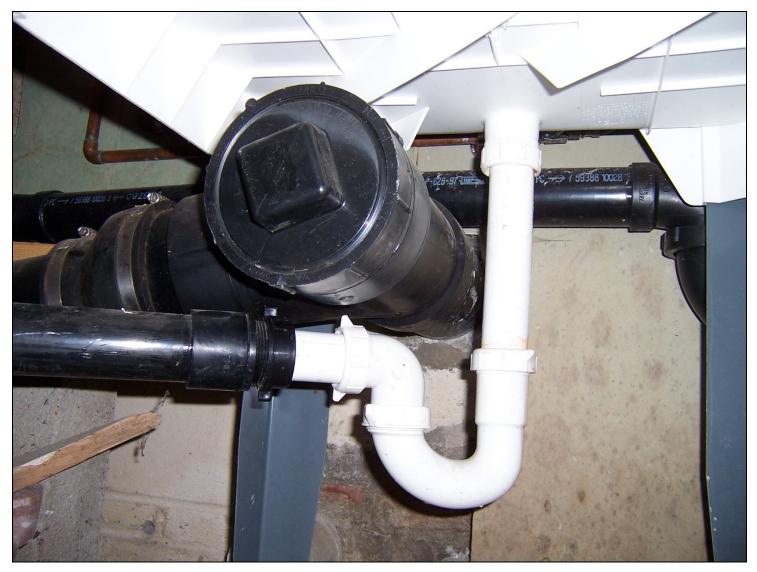
Figure 4: 4 inch to 3 inch reducer in drain line

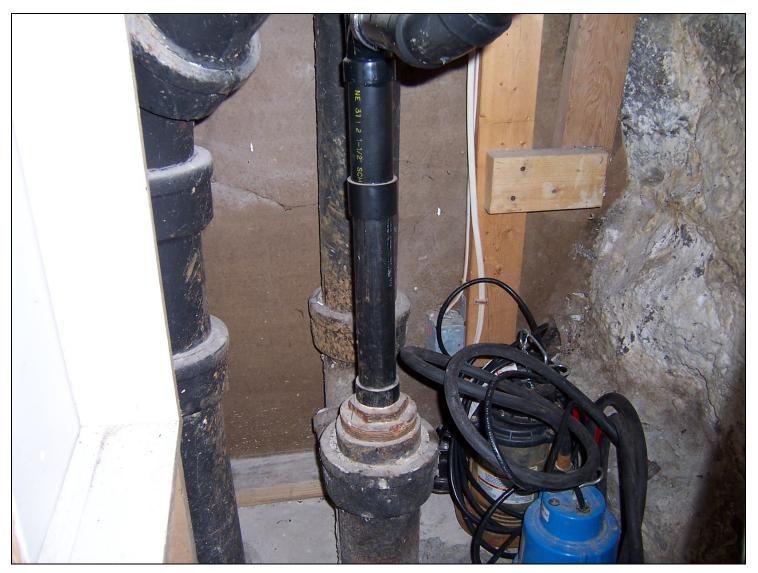
Figure 5: ABS mixed with PVC, no Vent and illegal pressure fitting, also pictured is the misplaced cleanout in drain line

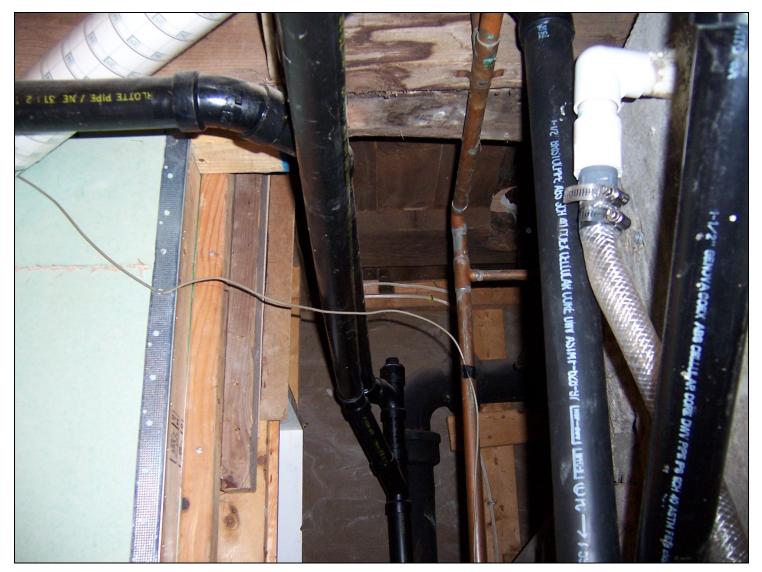
Figure 6: Drains can not be fed into cleanout

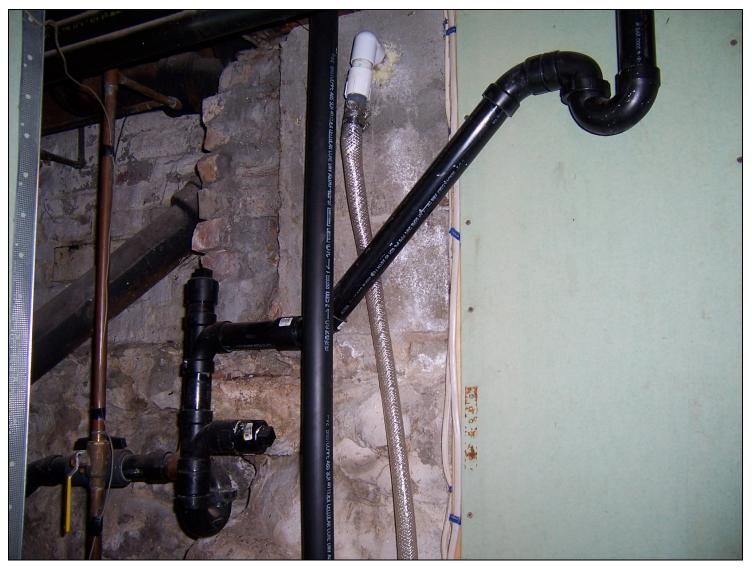
Figure 10: Original drain location cut and capped
